**Fenwick Solar Farm
EN010152**

**Landscape and Visual Supplementary Report
Document Reference: EN010152/APP/8.23**

- 1.1.1 Iceni Projects (Iceni) have prepared this Landscape and Visual Supplementary Report in response to the Relevant Representation made by City of Doncaster Council (CDC) **[RR-001]** (CDC's Relevant Representation) in relation to the proposed Fenwick Solar Farm (the Proposed Development). This was informed by a review of the Landscape and Visual Impact Assessment (LVIA) which was carried out by LUC on behalf of CDC.

Appendix B – Appendix 8-5: Hedgerow Report, Annex A, Figure 8-5-2: Hedgerow Removal Plan [APP-150]

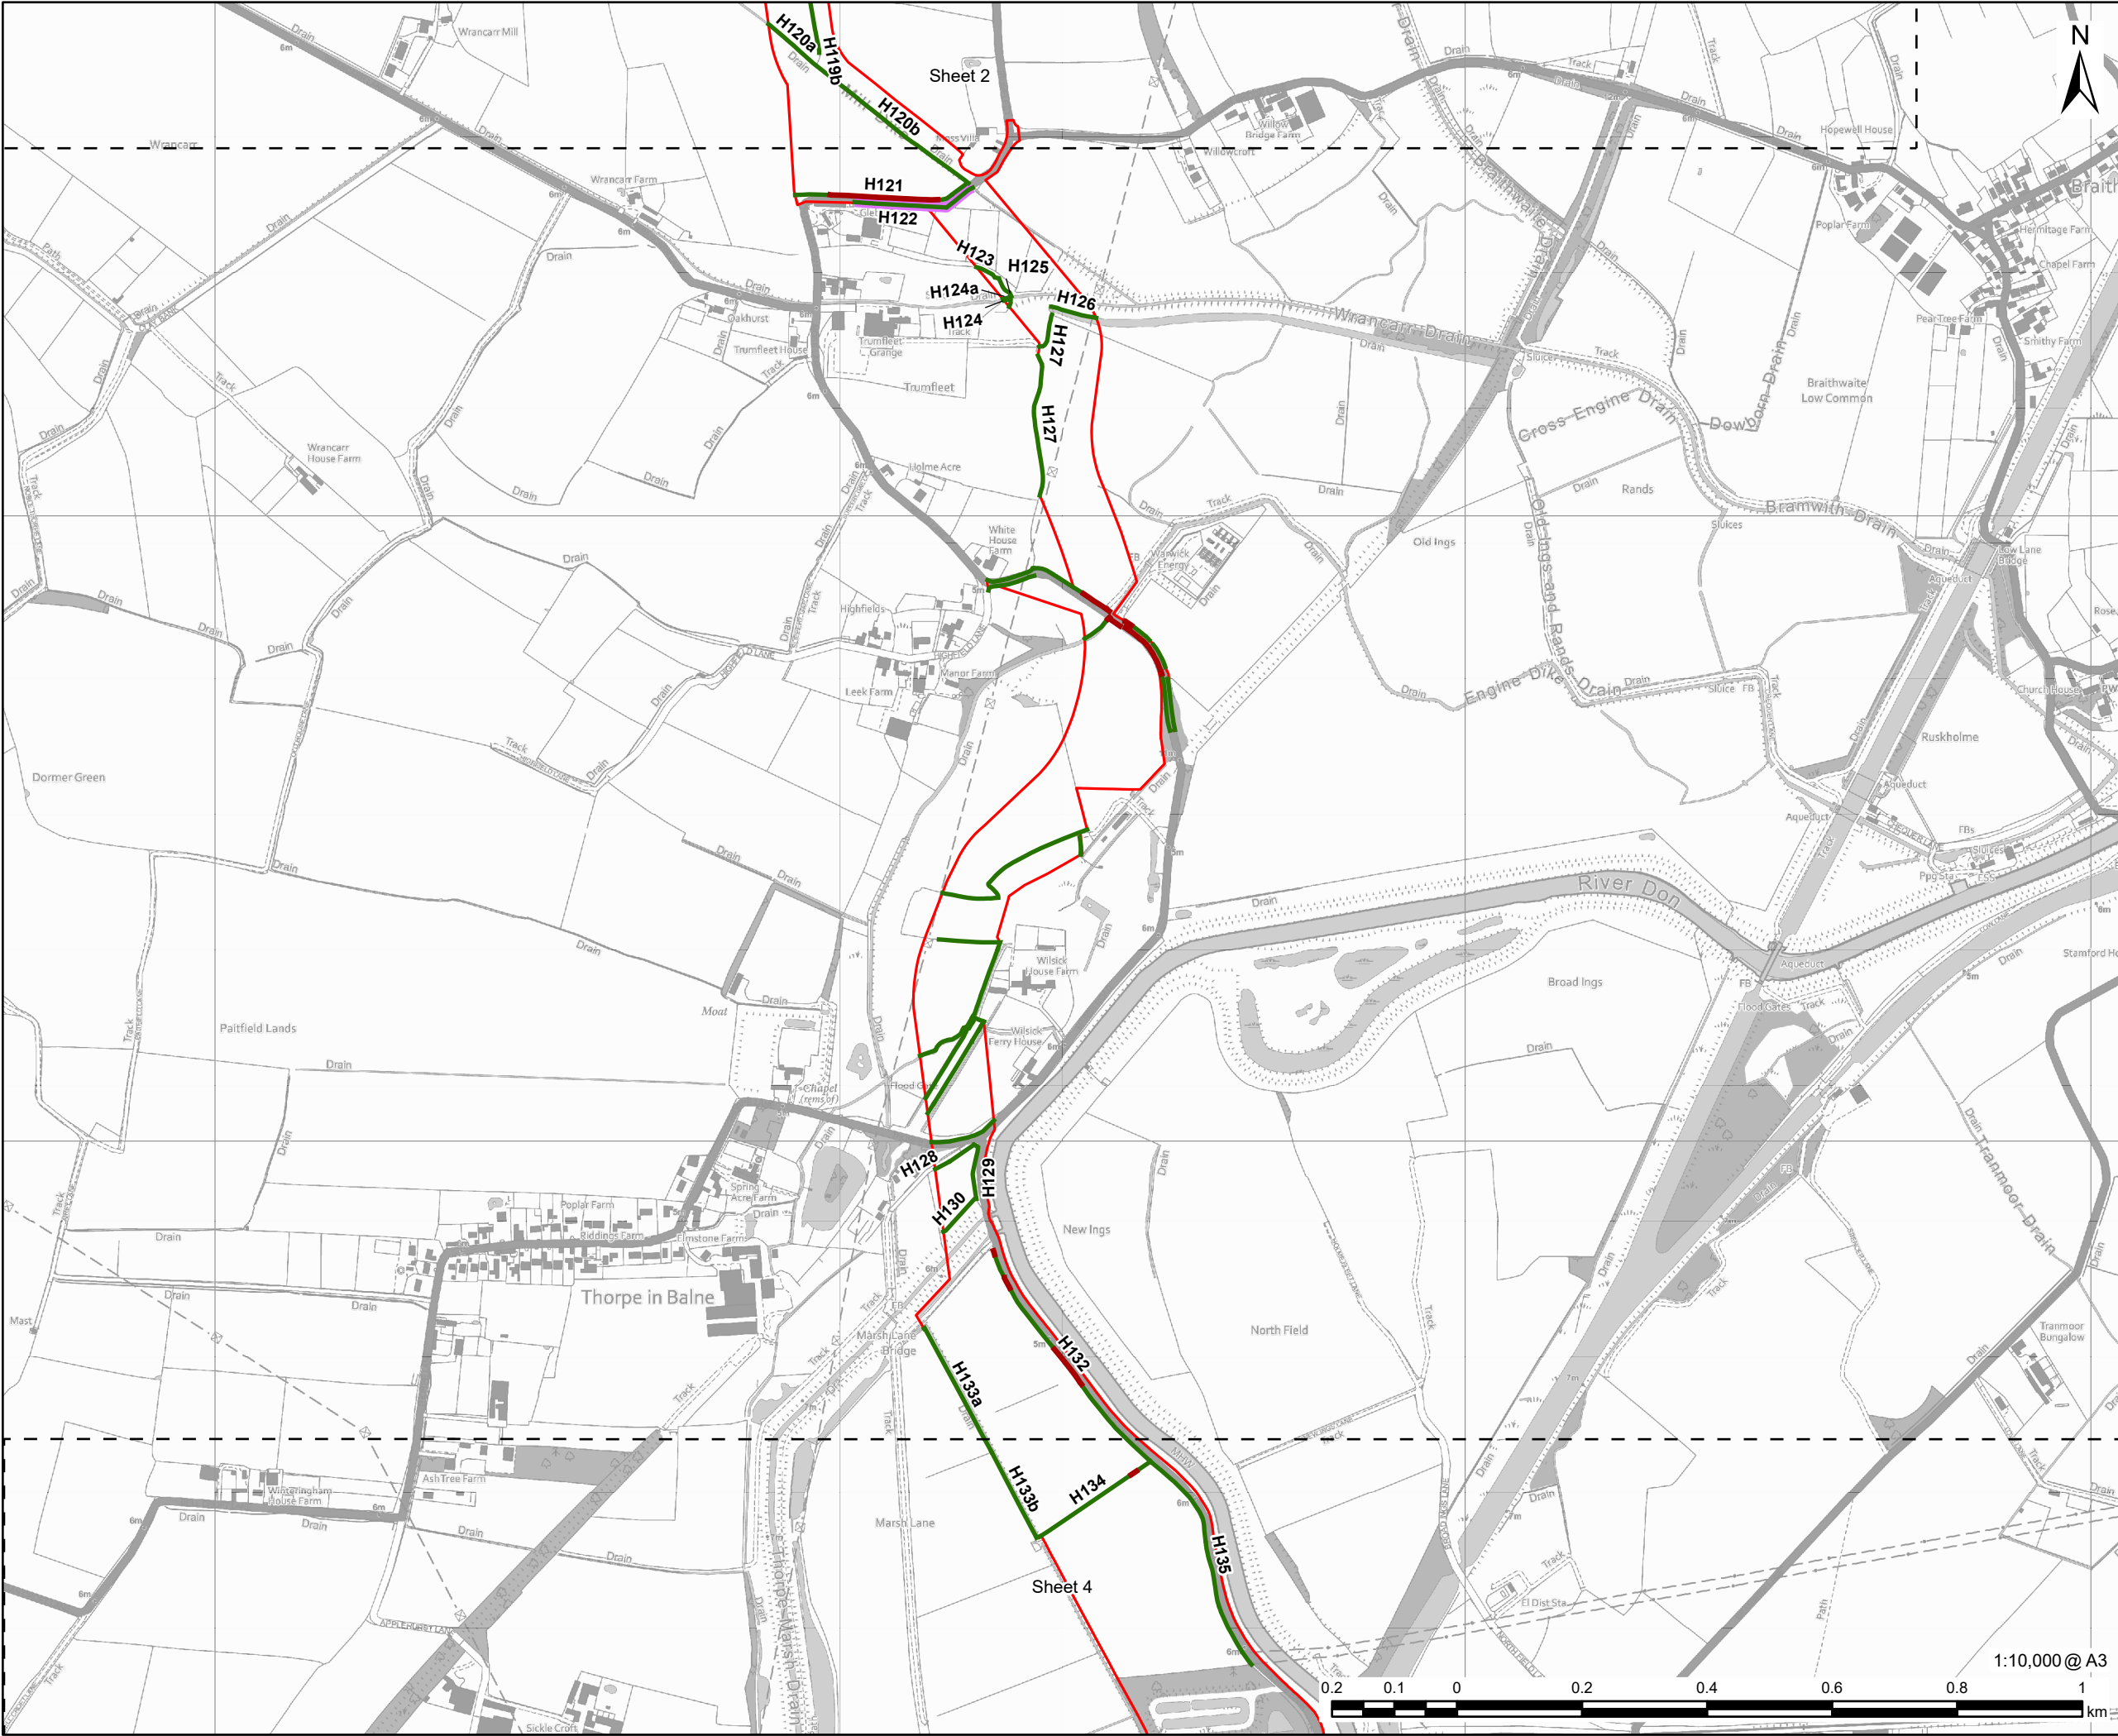
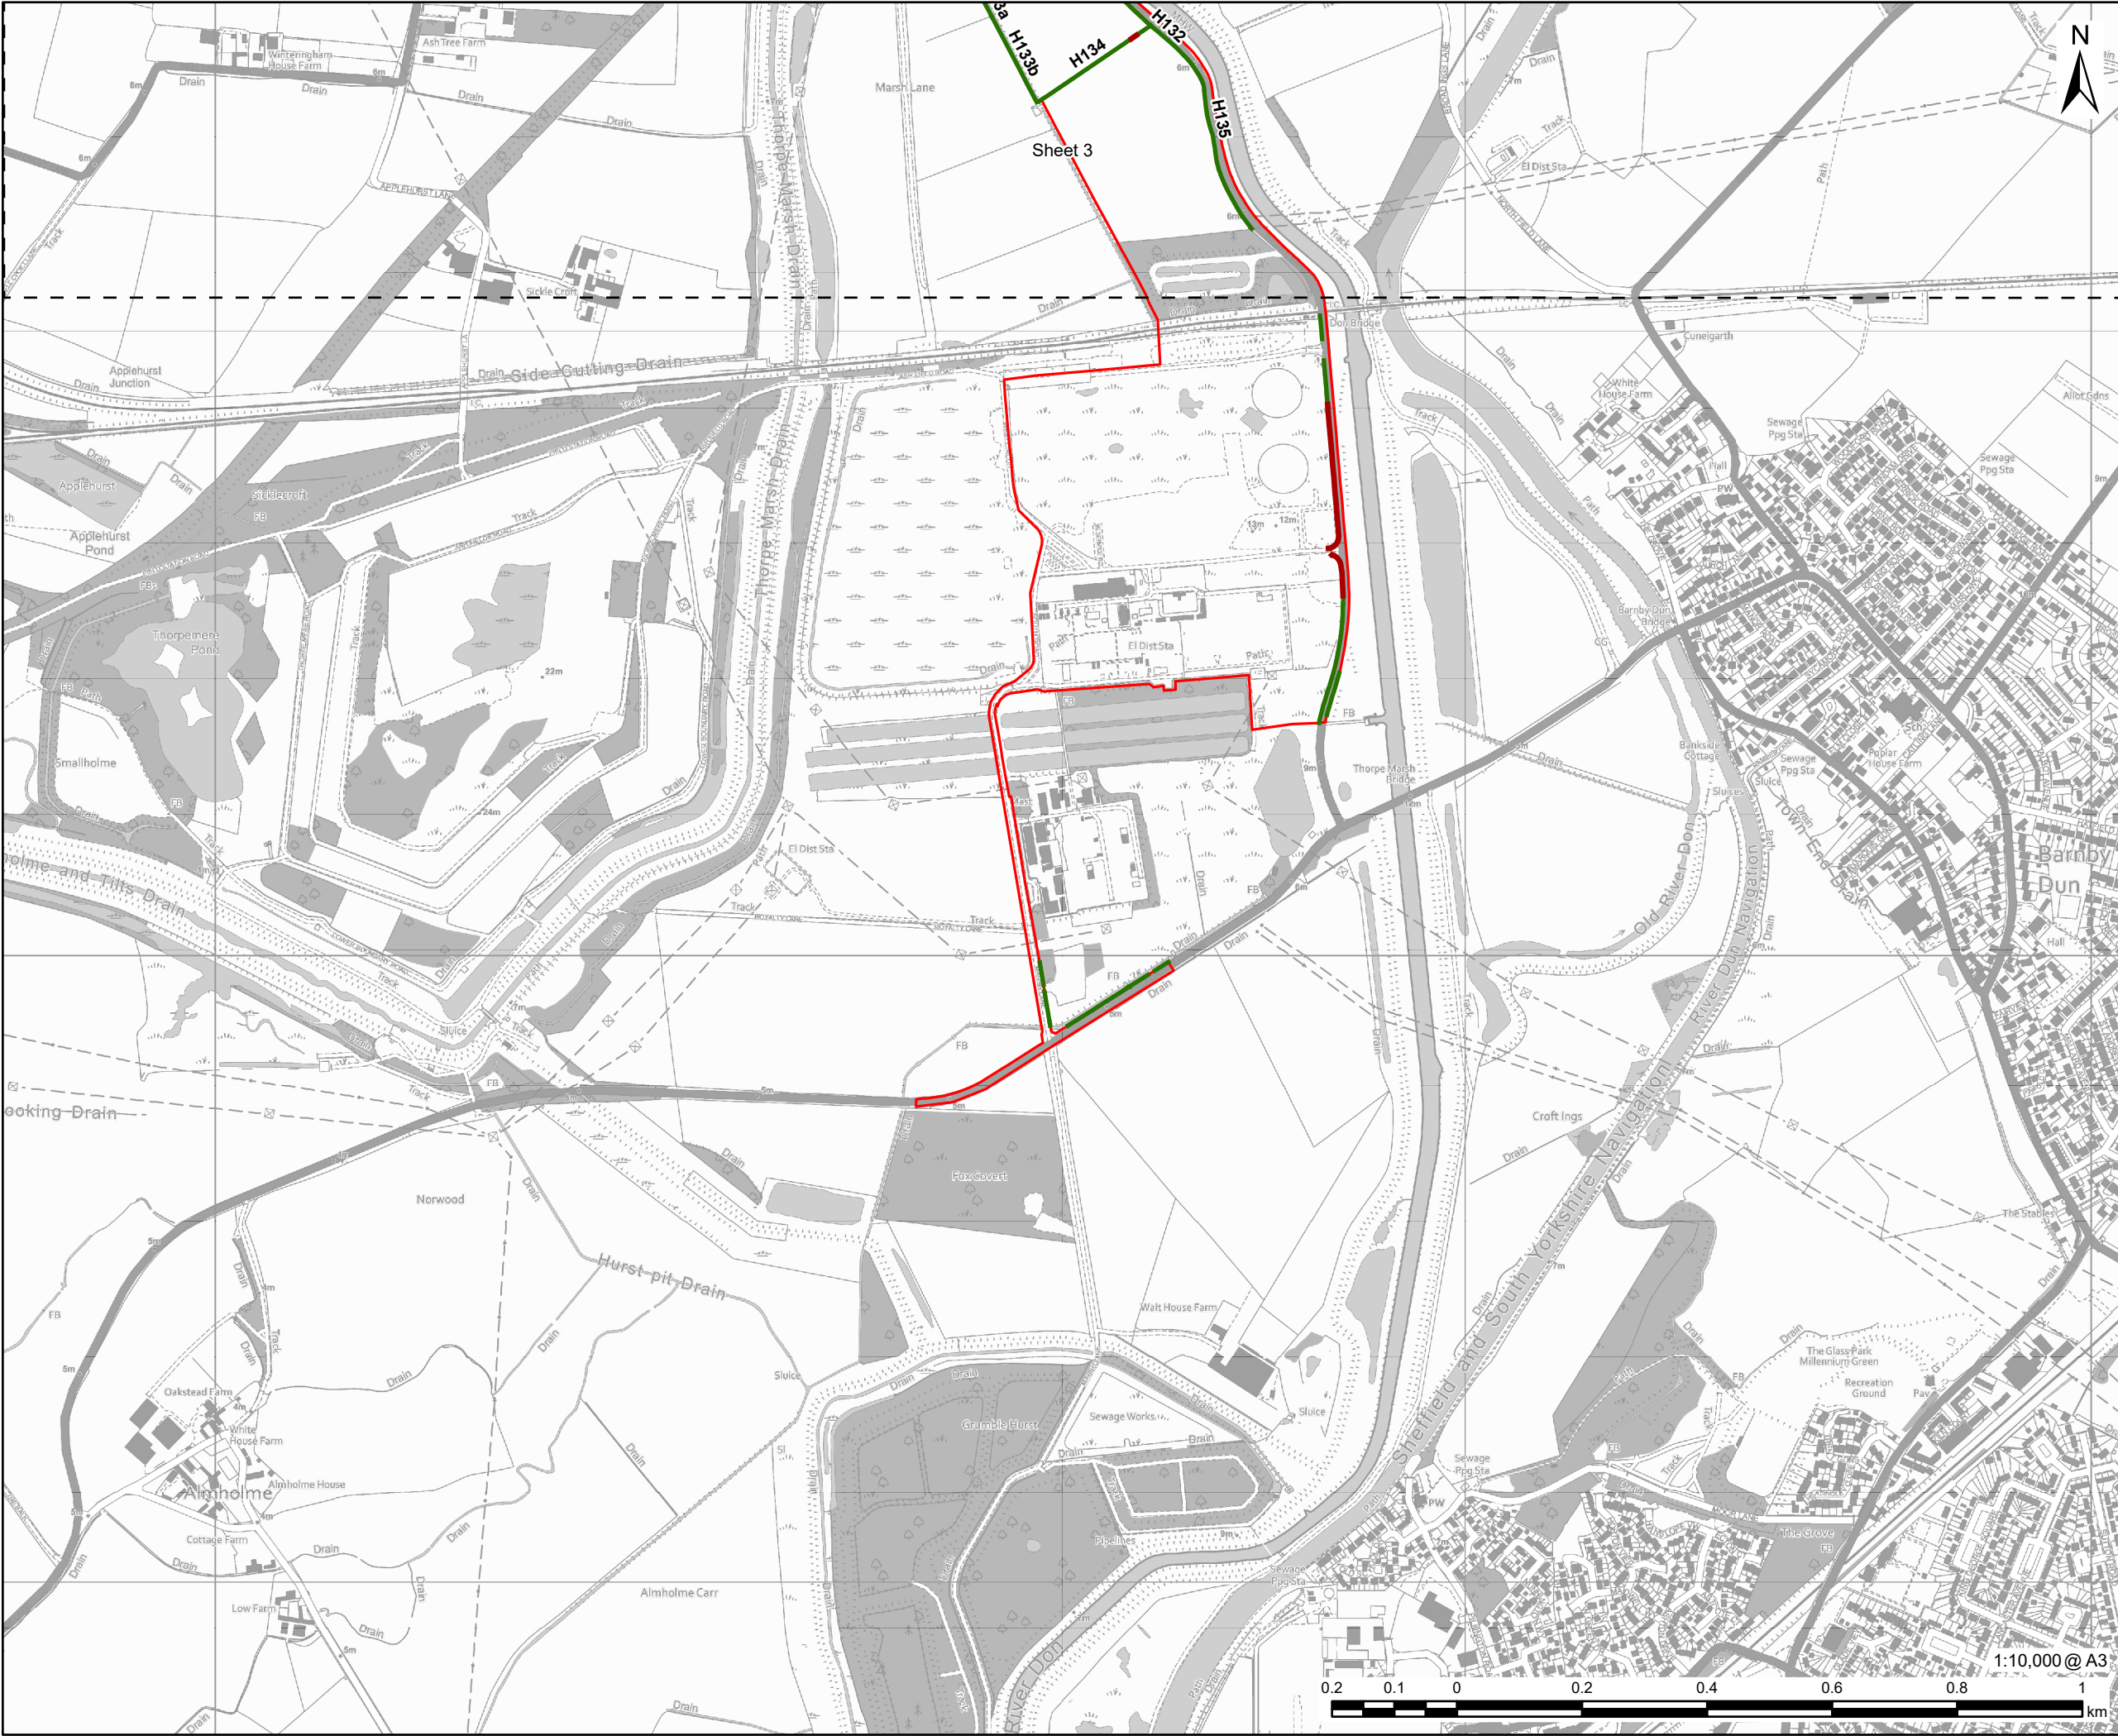
2.1.35 Whilst the Scheme does propose the removal of some stretches of hedgerow and trees to accommodate access and the laying of cables, as shown on Figure 8-5-2: Hedgerow Removal in **ES Volume III Appendix 8-5: Hedgerow Report [APP-150]**, there would be an overall increase in structural vegetation, habitat and natural capital assets across the Site. As noted within the **Biodiversity Net Gain Assessment [APP-200]**, there would be a 36.46% increase in habitat area units, a 62.75% increase in hedgerow units, and a 24.97% increase in watercourse units, resulting from habitat enhancement and creation across the Solar PV Site and Grid Connection Corridor. These would be established at Year 15 and would therefore bring with them beneficial landscape change.

- The Scheme avoids the need to fell woodland, including at Bunfold Shaw. Vegetation removal has been limited to where necessary for access and laying the of cables, as shown on Figure 8-5-2: Hedgerow Removal in **ES Volume III Appendix 8-5: Hedgerow Report [APP-150]**.
